CITY OF MANDAN, NORTH DAKOTA MAIN STREET WATER IMPROVEMENTS DISTRICT #39, WATER IMPROVEMENT PROJECT 96-2, PHASE III

Record Drawing

DATE: 2-14-97

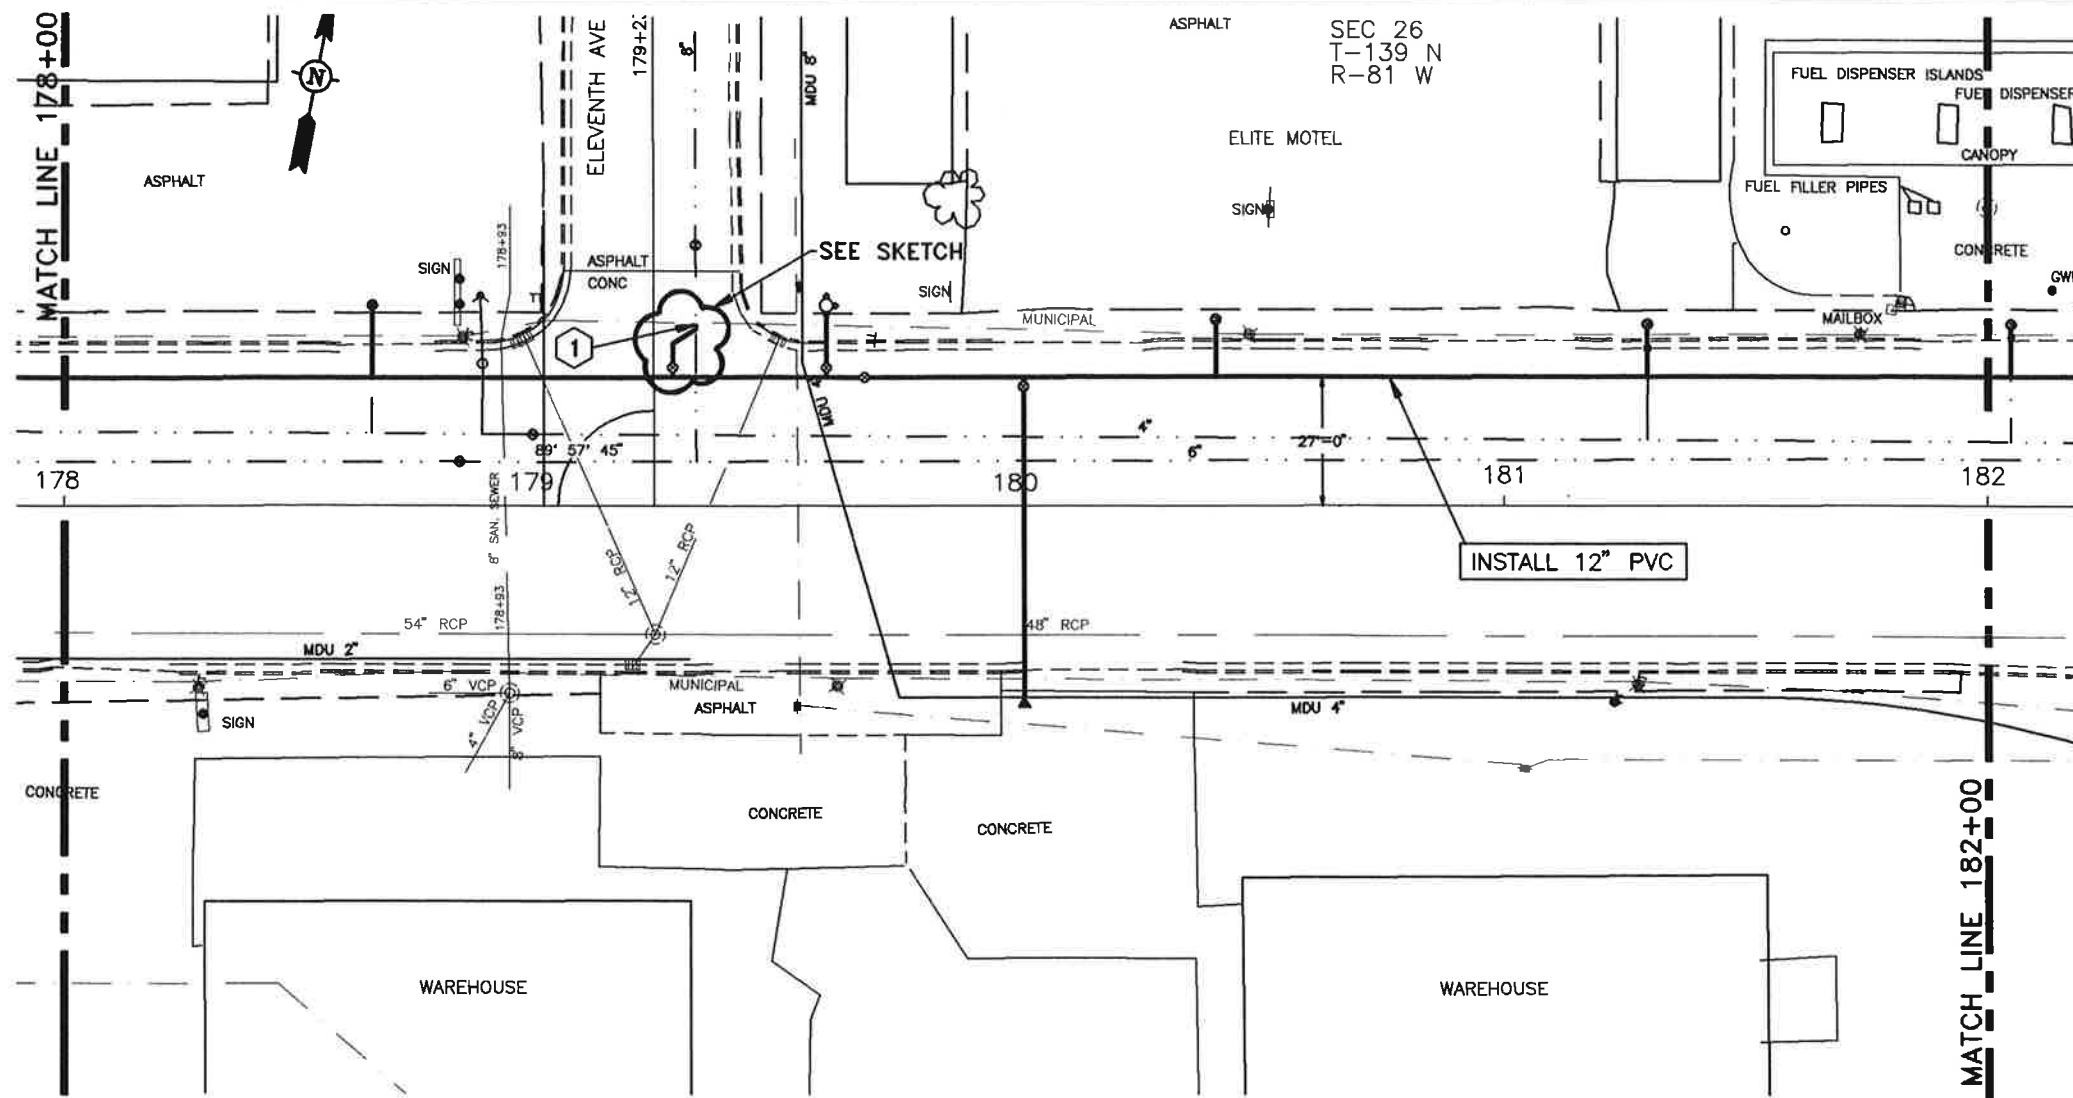
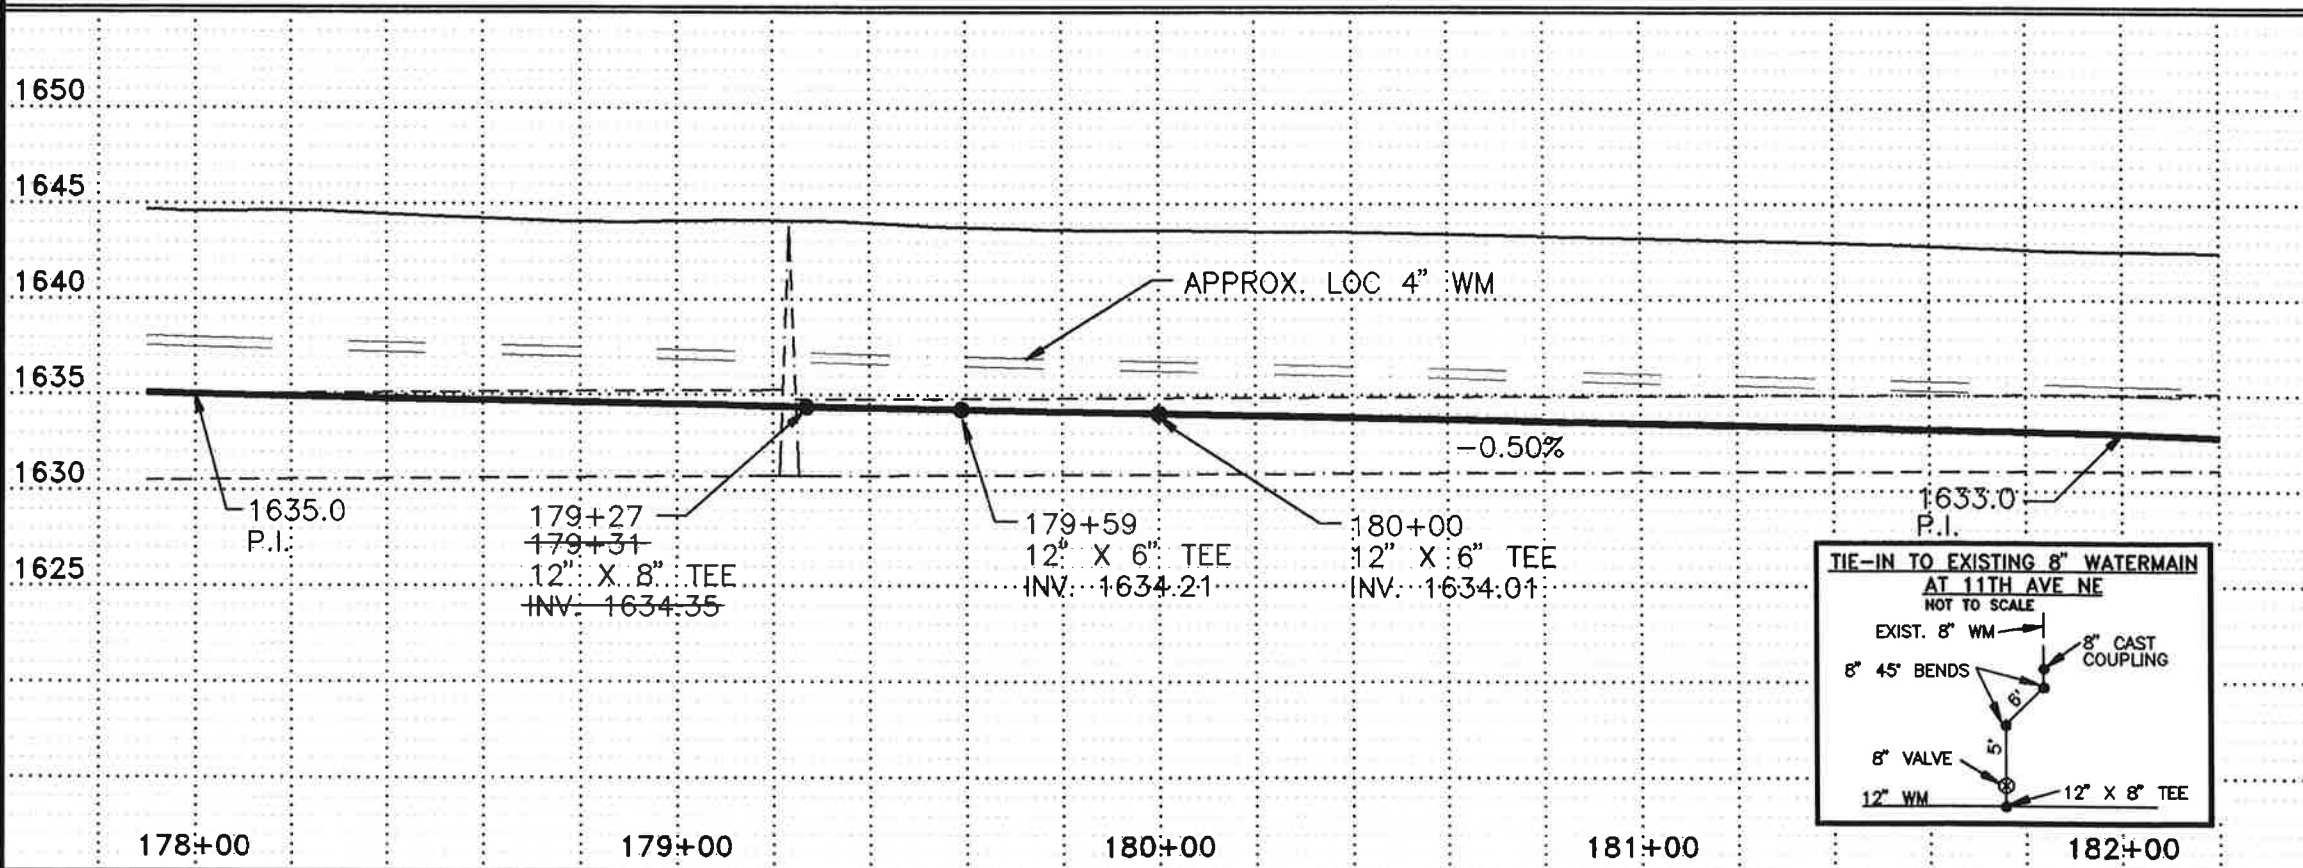
6" HYDRANT	179+59 -42'47" LT	1 EA
GATE VALVE AND BOX, 6"	179+59 -29'30" LT	1 EA
	180+00 -25'24" LT	1 EA
GATE VALVE AND BOX, 8"	+27 179+34 -29'30" LT	1 EA
GATE VALVE AND BOX, 12"	+67 179+28 - 27' LT	1 EA
WATERMAIN, 6" PVC	179+59 - 27' LT TO 179+59 -42'47" LT	15 20 LF
	180+00 - 27' LT TO 180+00 - 40' RT	67 LF
WATERMAIN, 8" PVC	+27 179+34 - 27' LT TO 179+34 -37'35" LT	11 8-LF
WATERMAIN, 12" PVC	178+00 - 27' LT TO 182+00 - 27' LT	400 LF
FITTINGS, DUCTILE IRON		
+27 179+34 - 27' LT	12" X 8" TEE	123 437 LBS
179+59 - 27' LT	12" X 6" TEE	115 423 LBS
180+00 - 27' LT	12" X 6" TEE	115 423 LBS
180+00 - 40' RT	6" PLUG	15 LBS
180+00 - 15' LT	2 - 6" 1/8 BEND	76 LBS
178+27 - 33' LT	1 - 8" 1/8 BEND	38 LBS
179+31 - 37' LT	1 - 8" 1/8 BEND	38 LBS
WATER SERVICE LINE 1-1/2" COPPER		
178+65 - 27' LT TO 178+65 - 42' LT	15 LF	
181+30 - 27' LT TO 181+30 -38'30" LT	11 42 LF	
WATER SERVICE LINE 2" COPPER		
180+40 - 27' LT TO 180+40 -38'30" LT	11 42 LF

178+65 - 27' LT TO 178+65 - 42' LT	15 LF	
WATER SERVICE CONNECTION		
178+65 - 27' LT	1 EA - 2" CONNECTION	
180+40 - 27' LT	1 EA - 2" CONNECTION	
181+30 - 27' LT	1 EA - 1 1/2" CONNECTION	
CURB STOP AND BOX 1-1/2"		
178+65 - 42' LT	1 EA	
181+30 -38'30" LT	1 EA	
CURB STOP AND BOX 2"		
180+40 -38'30" LT	1 EA	
178+65 - 42' LT	1 EA	
REMOVE HYDRANT		
178+90 - 30' LT	1 EA

① CONNECTED
CONNECT NEW 8" W.M. TO
EXISTING 8" W.M.

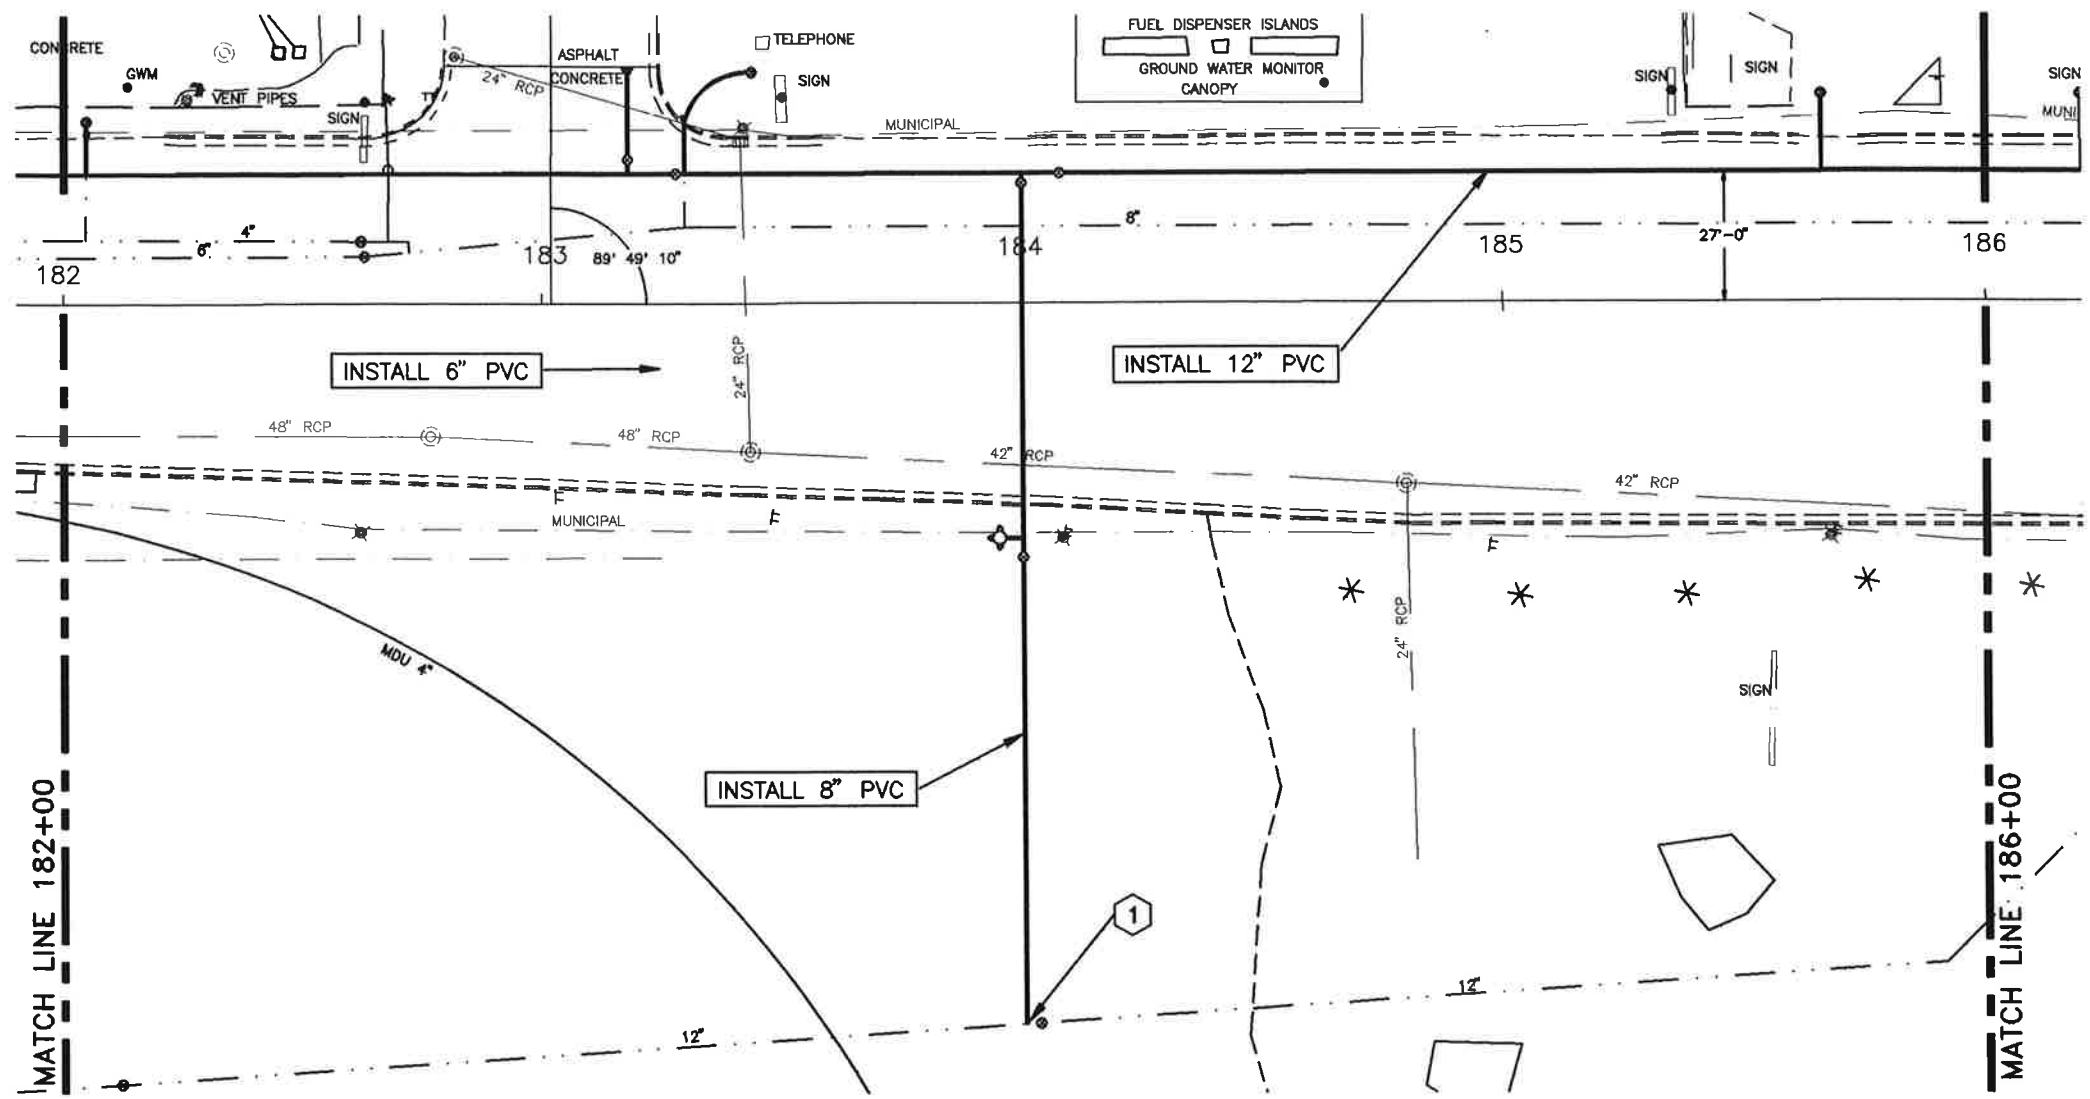
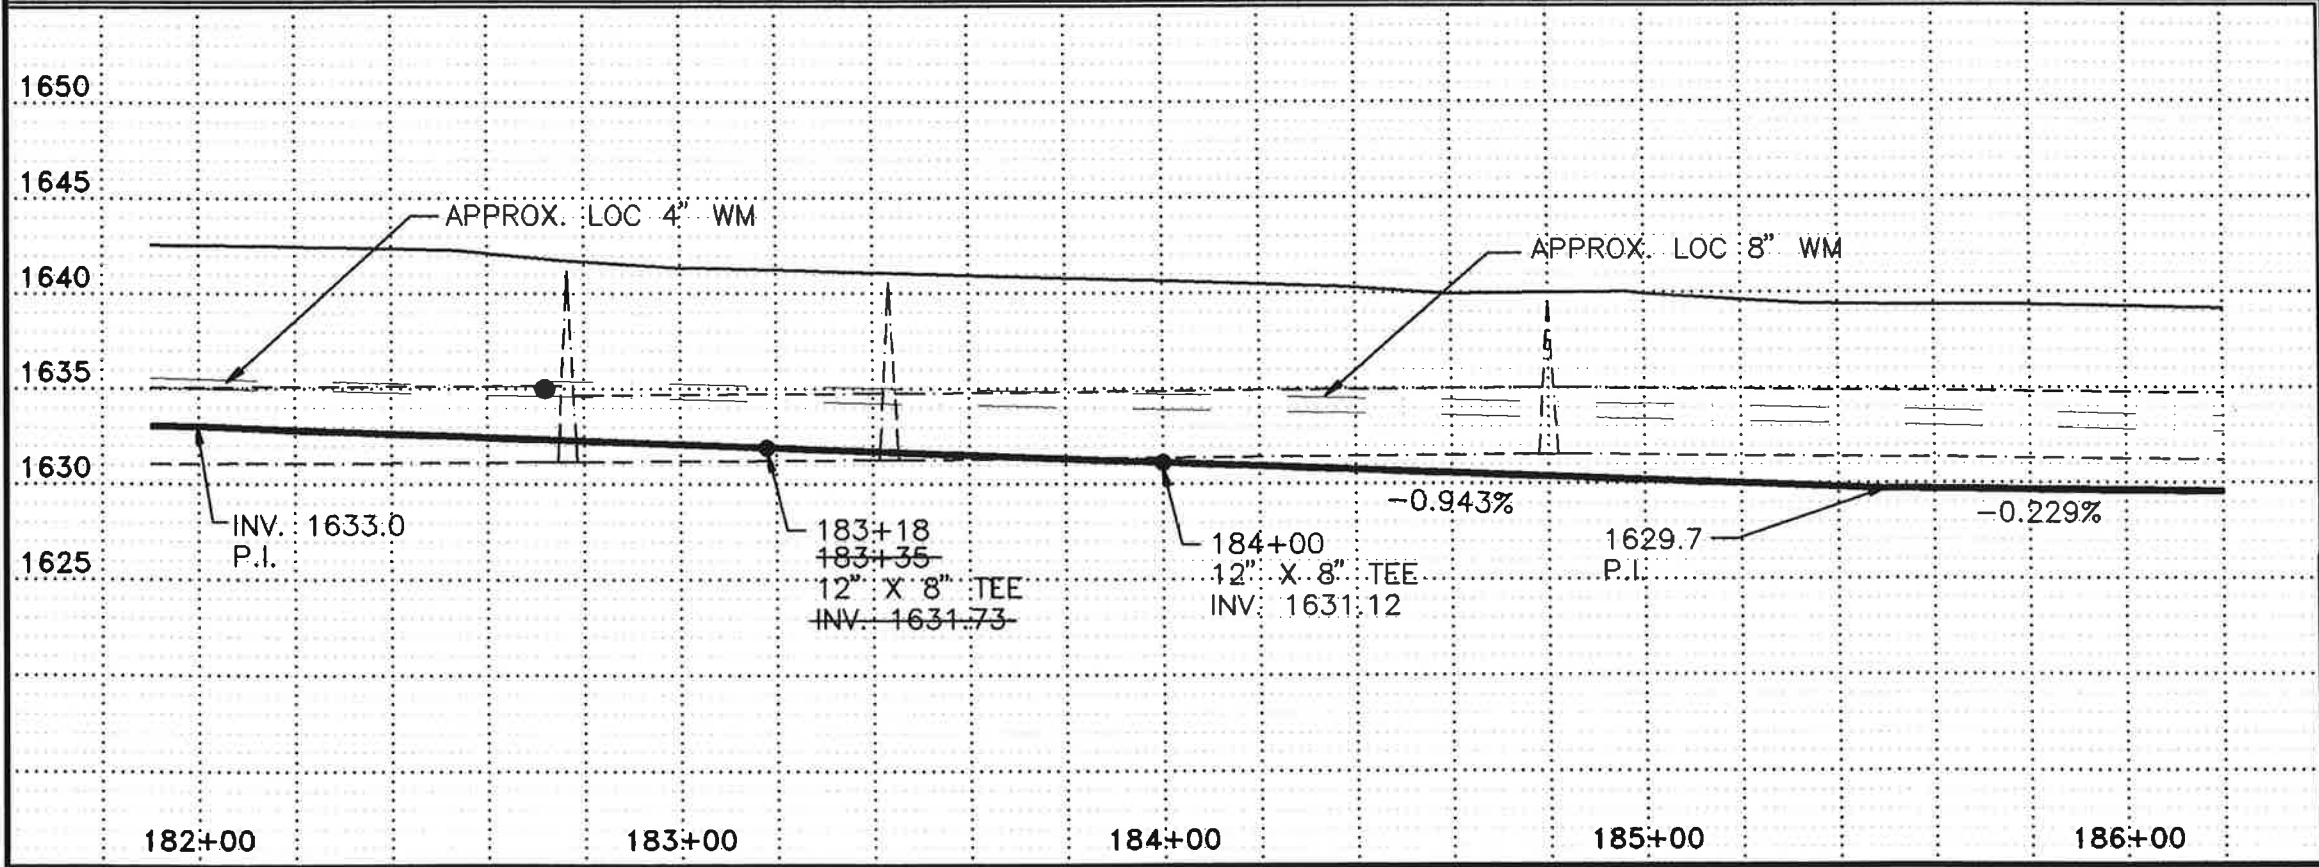
6" HYDRANT			
+95 183+25	-49' 41" RT	1 EA	
GATE VALVE AND BOX, 6"			
183+25	24' LT	1 EA	
GATE VALVE AND BOX, 8"			
+18 183+35	-29' 30" LT	1 EA	
184+00	-29' 24" LT	1 EA	
184+00	-53' 47" RT	1 EA	
184+03	150' RT	1 EA	
GATE VALVE AND BOX, 12"			
+28 183+32	- 27' LT	1 EA	
+08 184+03	- 27' LT	1 EA	
184+02	- 156' RT	1 EA	
WATERMAIN, 6" PVC			
183+25	- 27' LT TO 183+25	41' RT	68 LF
184+00	- 49' RT TO 183+95	- 49' RT	5 LF
WATERMAIN, 8" PVC			
+18 183+35	- 27' LT TO 183+35	- 47' LT	183 20 LF
184+00	- 27' LT TO 184+00	- 156' RT	177 LF
WATERMAIN, 12" PVC			
182+00	- 27' LT TO 186+00	- 27' LT	400 LF
184+00	- 156' RT		4 LF
FITTINGS, DUCTILE IRON			
184+00 183+25	-49' 27' LT RT	8" X 6" TEE	80 +23 LBS
183+25	26' RT	6" 1/8 BEND	31 LBS
183+25	28.5' RT	6" 1/8 BEND	31 LBS
+18 183+35	- 27' LT	12" X 8" TEE	123 +37 LBS
+18 183+35	- 47' LT	8" PLUG	26 LBS
184+00	- 27' LT	12" X 8" TEE	123 +37 LBS
184+00	-156' LT	12" X 8" TEE	123 -82 LBS
WATER SERVICE LINE 1-1/2" COPPER

182+05	- 27' LT TO 182+05	-38' 39" LT	11 +2 LF
183+30	- 27' LT TO 183+30	-48' 47" LT	21 +20 LF
+66 185+65	- 27' LT TO 185+65	-43' 40" LT	16 +13 LF
WATER SERVICE CONNECTION 1-1/2"			
182+05	- 27' LT	1 EA	
183+30	- 27' LT	1 EA	
+66 185+65	- 27' LT	1 EA	
CURB STOP AND BOX 1-1/2"			
182+05	-38' 39" LT	1 EA	
+44 183+30	-47' LT	1 EA	
+66 185+65	-43' LT	1 EA	
REMOVE HYDRANT			
182+67	- 43' LT	1 EA	
POLYSTYRENE INSULATION			
184+00	- 35' RT		128 BOFT
